Meeting Minutes Transmittal/Approval
Unit Manager's Meeting: 100 Aggregate Area/100 Area Operable Units
450 Hills Street, Richland, Washington
June 24, 1992

Meeting Minutes are attached. Minutes are comprised of the following:

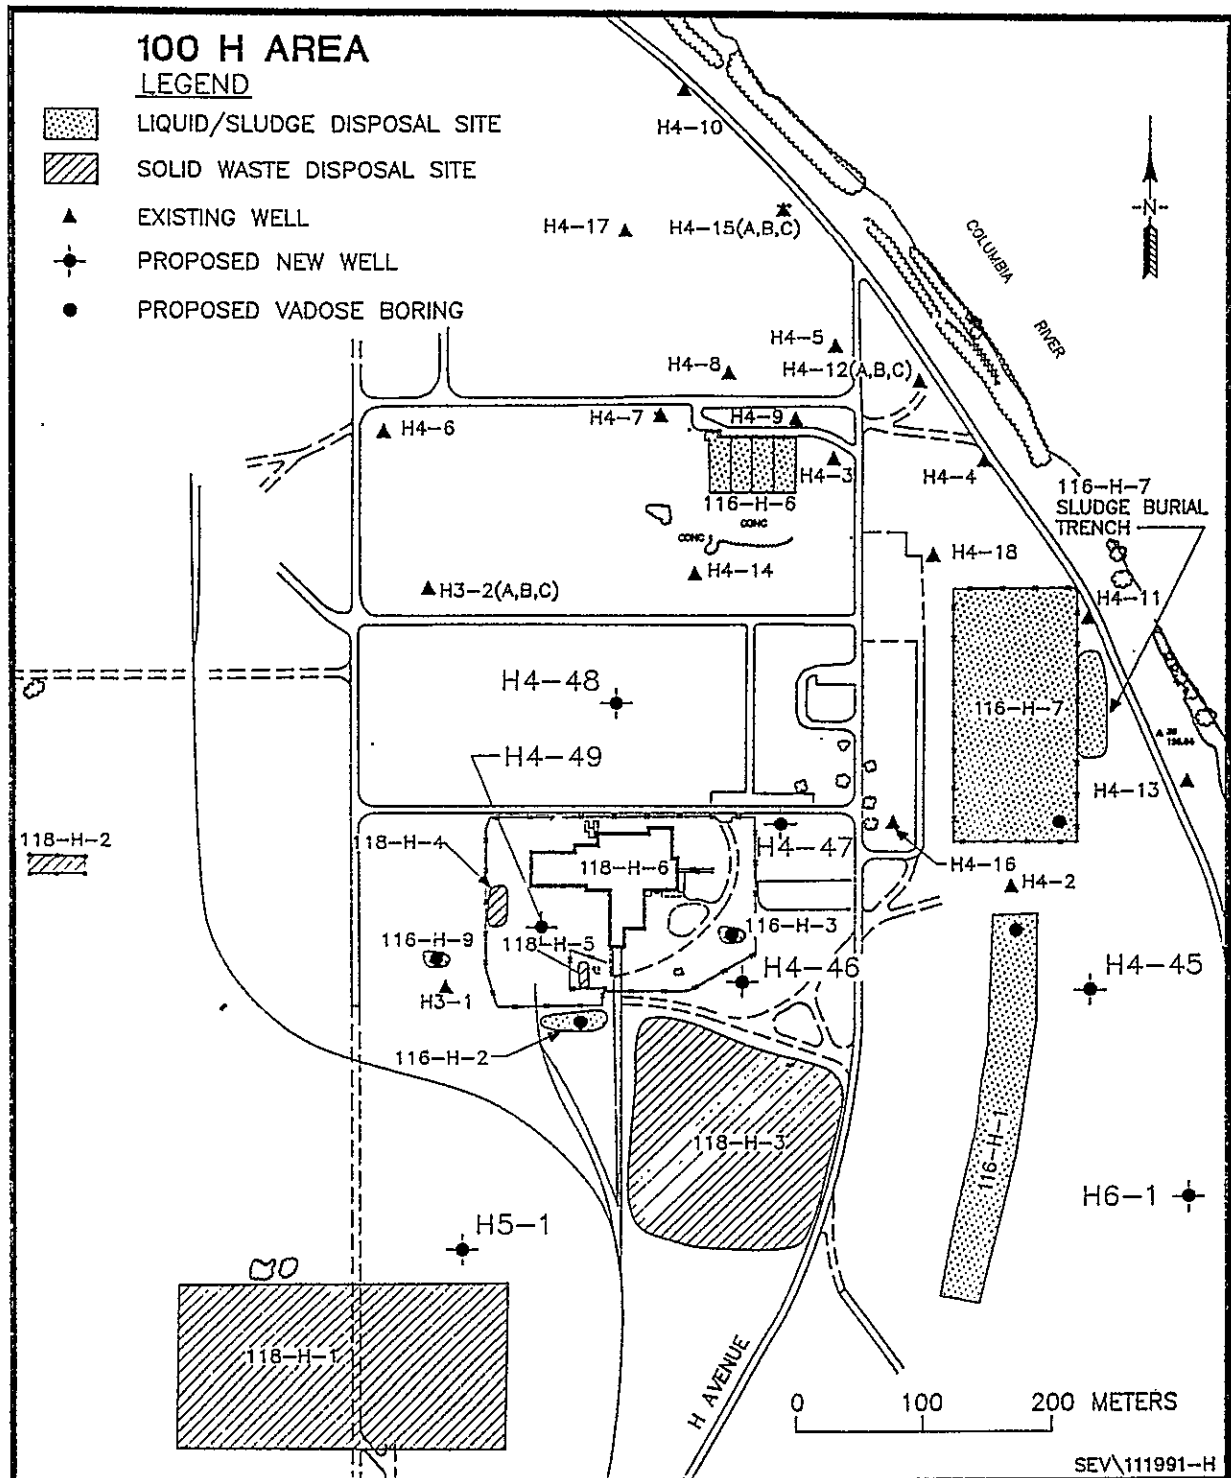
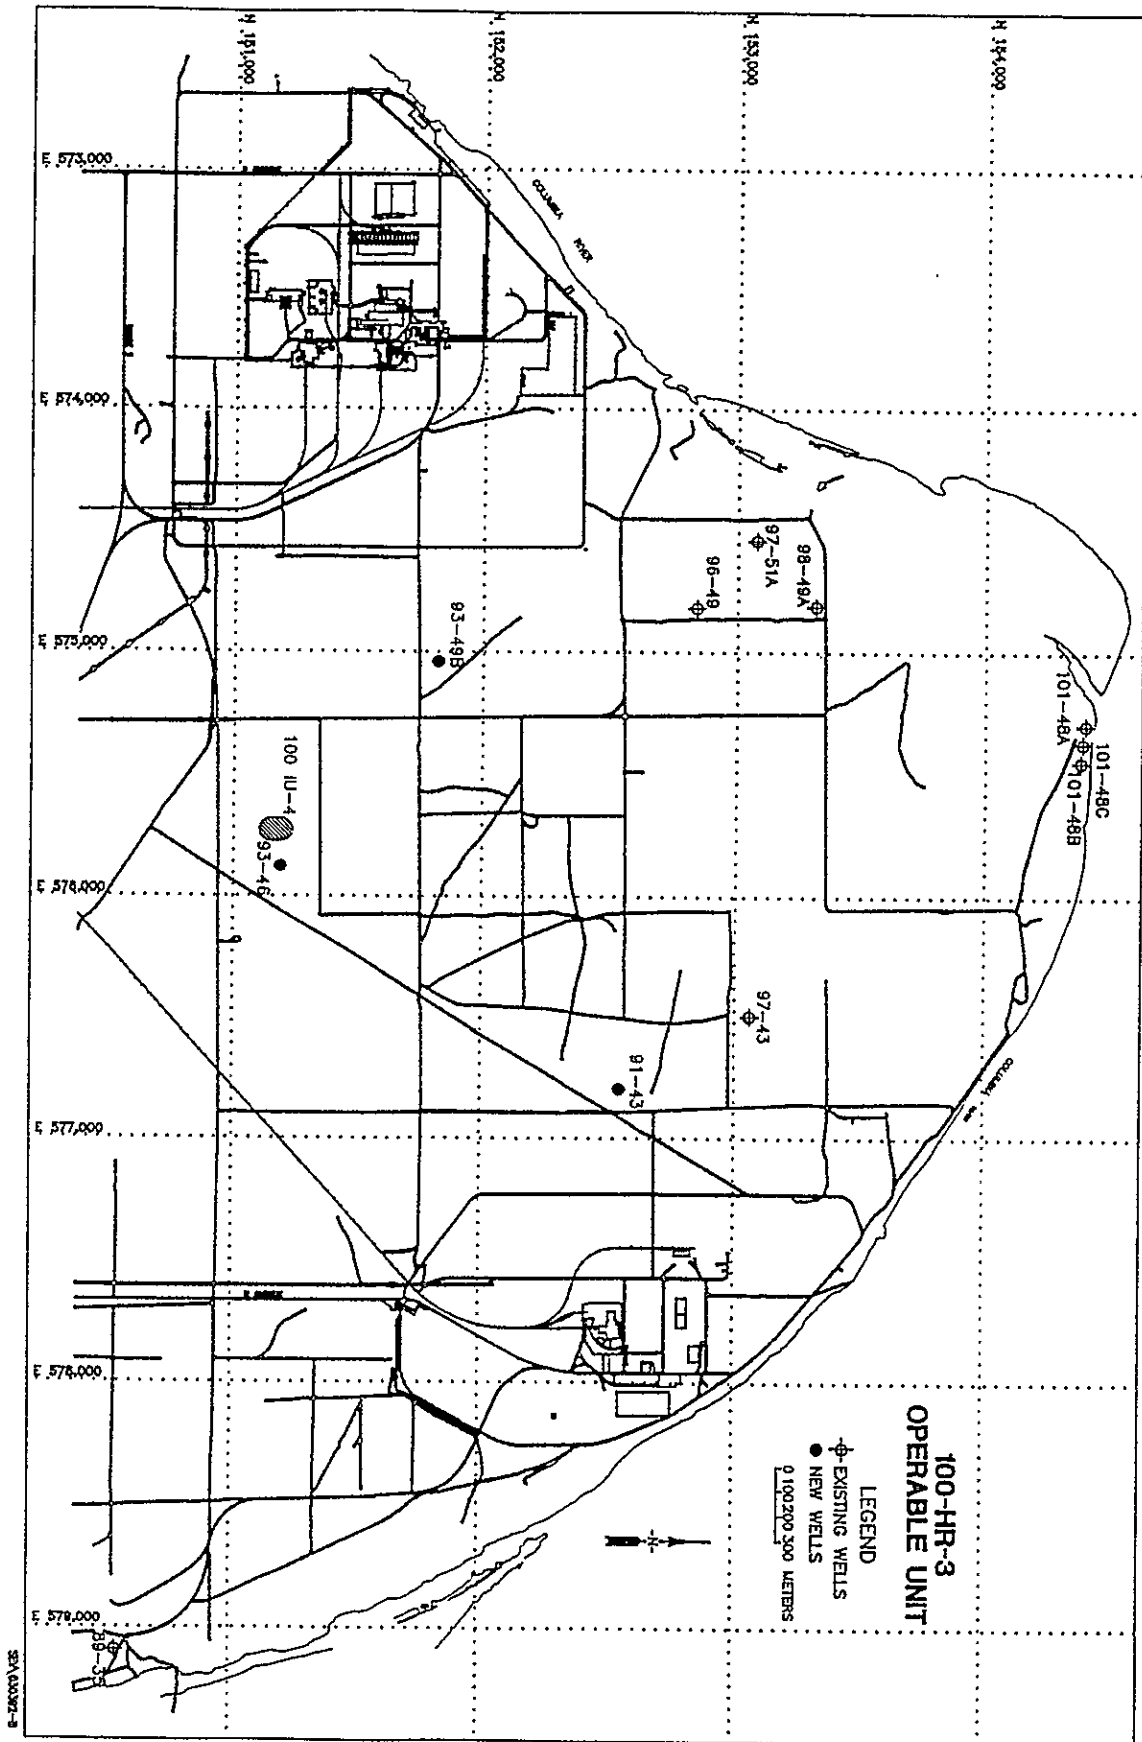
Control Number 15	100 NPL Agreement/Change Control Form Change <input checked="" type="checkbox"/> Agreement <input type="checkbox"/> Information Operable Unit(s) _____	Date Submitted 6/24/92 Date Approved																								
Document Number & Title: 100-HR-3 Operable Unit Groundwater Monitoring Network		Date Document Last Issued First Issue																								
Originator S. E. Vukelich		Phone (509) 376-5158																								
Summary Description Proposed 100-HR-3 Groundwater Network.																										
Justification and Impact of Change

This 100 HR-3 groundwater monitoring network integrates sampling efforts from the CERCLA and the RCRA programs. The primary network consists of 22 CERCLA wells drilled in FY92. The three supplementary networks consist of the D Area RCRA wells, the H Area RCRA wells and the existing wells deemed fit-for-use. In addition, Well 199-H4-2 (artesian well drilled into basalt) will be added to the network after it has been remediated. WHC is preparing remediation plans for the Regulator's approval.

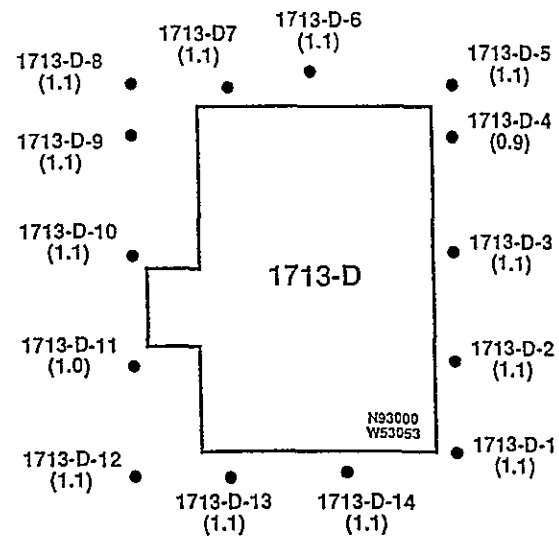
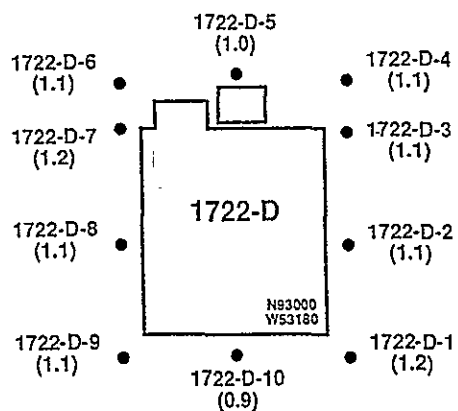
100 NPL Agreement/Change Control Form		
Control Number 18	<input checked="" type="checkbox"/> Change <input type="checkbox"/> Agreement <input type="checkbox"/> Information Operable Unit(s) <u>100-DR-1</u>	Date Submitted: 05-05-92 Date Approved:
Document Number & Title: DOE/RL-89-09, Draft B, RCRA Facility Investigation/Corrective Measures Study Work Plan for the 100-DR-1 Operable Unit, Hanford Site, Richland, Washington, August 1990.		Date Document Last Issued: September 1991
Originator: N.M. Naiknimbalkar		Phone: 376-8739
Summary Description: Section 5.1.2.3.5 Activity 2c-5--Soil Gas Survey o 1713-D instrument and electrical development laboratory		
Justification and Impact of Changes: 1713-D instrument and electrical development laboratory is a low priority support facility. The soil gas surveys were conducted at this site. The samples contained less-than detectable or insignificant concentrations of t-12-DCE, BENZENE, TOLUENE, ETHYLBENZENE, TOTAL XYLENES, 1,1,1-TCA, TCE and PCE chlorinated solvent vapors. In summary no significant contamination was encountered at this site. See attached 100-DR-1 Soil Gas Survey Results. Based upon the above documented information, it is recommended that no further activities be conducted at this location at this time.

The soil Gas surveys have been completed for these sites and no significant contamination was encountered. Based on this documented data it is recommended that these sites be postponed from any further activities at this time and be considered at the time of final remedy selection phase as described in Figure 4-1 (Final Remedy Selection Process) of the 100-DR-1 Work Plan, Draft D.

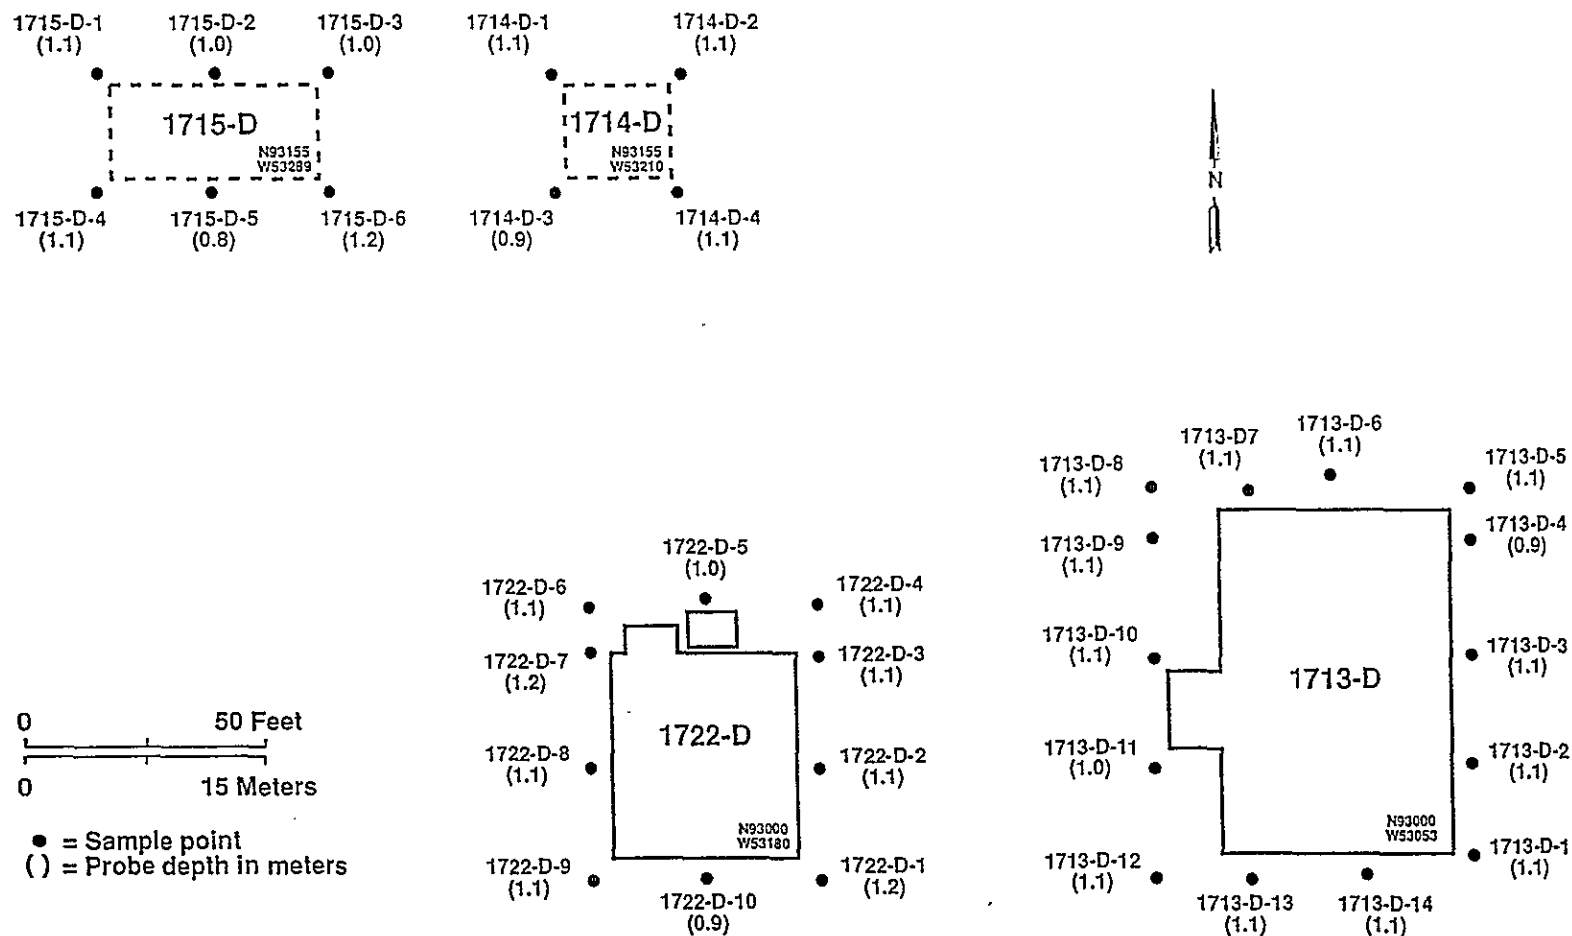
100 NPL Agreement/Change Control Form		
Control Number 19	<input checked="" type="checkbox"/> Change <input type="checkbox"/> Agreement <input type="checkbox"/> Information Operable Unit(s) <u>100-DR-1</u>	Date Submitted: 05-05-92 Date Approved:
Document Number & Title: DOE/RL-89-09, Draft B, RCRA Facility Investigation/Corrective Measures Study Work Plan for the 100-DR-1 Operable Unit, Hanford Site, Richland, Washington, August 1990.		Date Document Last Issued: September 1991
Originator: N.M. Naiknimbalkar		Phone: 376-8739
Summary Description: Section 5.1.2.3.5 Activity 2c-5--Soil Gas Survey o 1714-D solvent storage building		
Justification and Impact of Change: 1714-D solvent storage building is a low priority support facility. The soil gas surveys were conducted at this site. The samples contained less-than detectable or insignificant concentrations of t-12-DCE, BENZENE, TOLUENE, ETHYLBENZENE, TOTAL XYLENES, 1,1,1-TCA, TCE and PCE chlorinated solvent vapors. In summary no significant contamination was encountered at this site. See attached 100-DR-1 Soil Gas Survey Results. Based upon the above documented information, it is recommended that no further activities be conducted at this location at this time.

The soil Gas surveys have been completed for these sites and no significant contamination was encountered. Based on this documented data it is recommended that these sites be postponed from any further activities at this time and be considered at the time of final remedy selection phase as described in Figure 4-1 (Final Remedy Selection Process) of the 100-DR-1 Work Plan, Draft D.

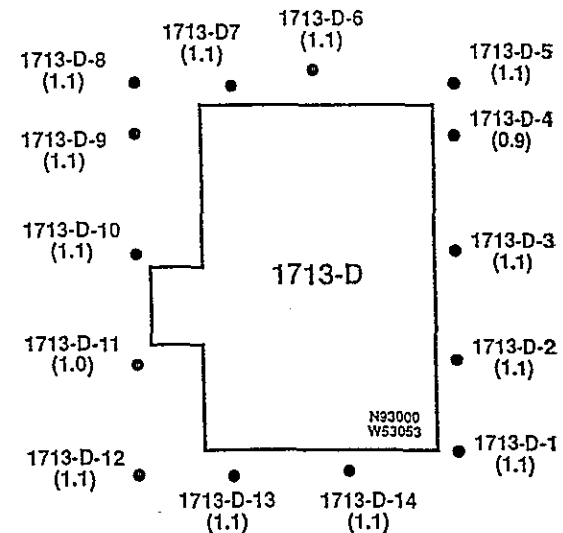
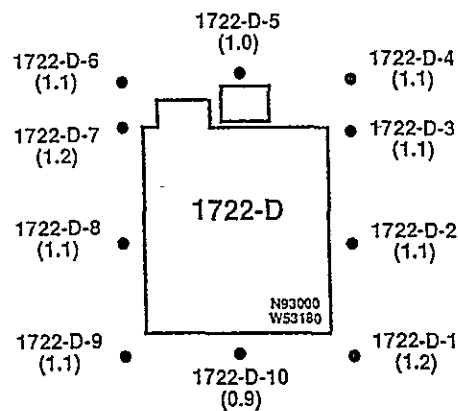
100 NPL Agreement/Change Control Form		
Control Number 20	<input checked="" type="checkbox"/> Change <input type="checkbox"/> Agreement <input type="checkbox"/> Information Operable Unit(s) <u>100-DR-1</u>	Date Submitted: 05-05-92 Date Approved:
Document Number & Title: DOE/RL-89-09, Draft B, RCRA Facility Investigation/Corrective Measures Study Work Plan for the 100-DR-1 Operable Unit, Hanford Site, Richland, Washington, August 1990.		Date Document Last Issued: September 1991
Originator: N.M. Naiknimbalkar		Phone: 376-8739
Summary Description: Section 5.1.2.3.5 Activity 2c-5--Soil Gas Survey o 1715-D oil and paint storage		
Justification and Impact of Change: 1715-D oil and paint storage is a low priority support facility. The soil gas surveys were conducted at this site. The samples contained less-than detectable or insignificant concentrations of t-12-DCE, BENZENE, TOLUENE, ETHYLBENZENE, TOTAL XYLENES, 1,1,1-TCA, TCE and PCE chlorinated solvent vapors. In summary no significant contamination was encountered at this site. See attached 100-DR-1 Soil Gas Survey Results. Based upon the above documented information, it is recommended that no further activities be conducted at this location at this time.

The soil Gas surveys have been completed for these sites and no significant contamination was encountered. Based on this documented data it is recommended that these sites be postponed from any further activities at this time and be considered at the time of final remedy selection phase as described in Figure 4-1 (Final Remedy Selection Process) of the 100-DR-1 Work Plan, Draft D.

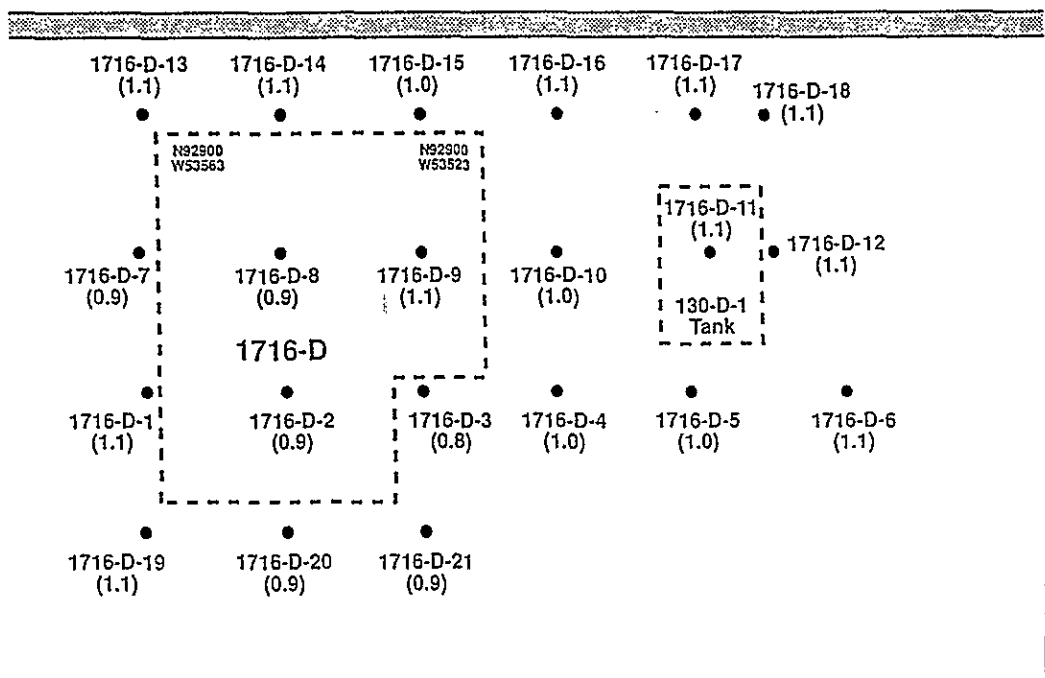
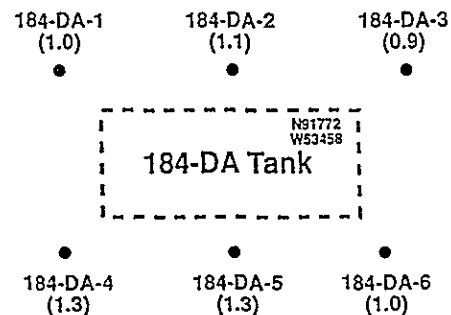
100 NPL Agreement/Change Control Form		
Control Number 21	<input checked="" type="checkbox"/> Change <input type="checkbox"/> Agreement <input type="checkbox"/> Information Operable Unit(s) <u>100-DR-1</u>	Date Submitted: 05-05-92 Date Approved:
Document Number & Title: DOE/RL-89-09, Draft B, RCRA Facility Investigation/Corrective Measures Study Work Plan for the 100-DR-1 Operable Unit, Hanford Site, Richland, Washington, August 1990.		Date Document Last Issued: September 1991
Originator: N.M. Naiknimbalkar		Phone: 376-8739
Summary Description: Section 5.1.2.3.5 Activity 2c-5--Soil Gas Survey o 1716-D gas station,		
Justification and Impact of Change: 1716 gas station is a low priority support facility. The soil gas surveys were conducted at this site. The samples contained less-than detectable or insignificant concentrations of t-12-DCE, BENZENE, TOLUENE, ETHYLBENZENE, TOTAL XYLENES, 1,1,1-TCA, TCE and PCE chlorinated solvent vapors. In summary no significant contamination was encountered at this site. See attached 100-DR-1 Soil Gas Survey Results. Based upon the above documented information, it is recommended that no further activities be conducted at this location at this time.

The soil Gas surveys have been completed for these sites and no significant contamination was encountered. Based on this documented data it is recommended that these sites be postponed from any further activities at this time and be considered at the time of final remedy selection phase as described in Figure 4-1 (Final Remedy Selection Process) of the 100-DR-1 Work Plan, Draft D.

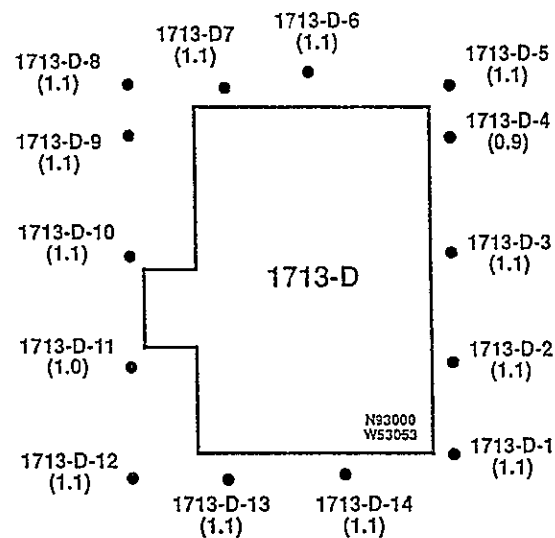
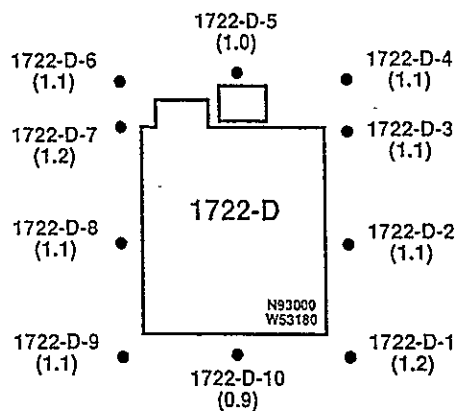
100 NPL Agreement/Change Control Form		
Control Number 22	<u>X</u> Change <u> </u> Agreement <u> </u> Information Operable Unit(s) <u>100-DR-1</u>	Date Submitted: 05-05-92 Date Approved:
Document Number & Title: DOE/RL-89-09, Draft B, RCRA Facility Investigation/Corrective Measures Study Work Plan for the 100-DR-1 Operable Unit, Hanford Site, Richland, Washington, August 1990.		Date Document Last Issued: September 1991
Originator: N.M. Naiknimbalkar		Phone: 376-8739
Summary Description: Section 5.1.2.3.5 Activity 2c-5--Soil Gas Survey o 1722-D equipment development laboratory		
Justification and Impact of Change: 1722-D equipment development laboratory is a low priority support facility. The soil gas surveys were conducted at this site. The samples contained less-than detectable or insignificant concentrations of t-12-DCE, BENZENE, TOLUENE, ETHYLBENZENE, TOTAL XYLENES, 1,1,1-TCA, TCE and PCE chlorinated solvent vapors. In summary no significant contamination was encountered at this site. See attached 100-DR-1 Soil Gas Survey Results. Based upon the above documented information, it is recommended that no further activities be conducted at this location at this time.

The soil Gas surveys have been completed for these sites and no significant contamination was encountered. Based on this documented data it is recommended that these sites be postponed from any further activities at this time and be considered at the time of final remedy selection phase as described in Figure 4-1 (Final Remedy Selection Process) of the 100-DR-1 Work Plan, Draft D.
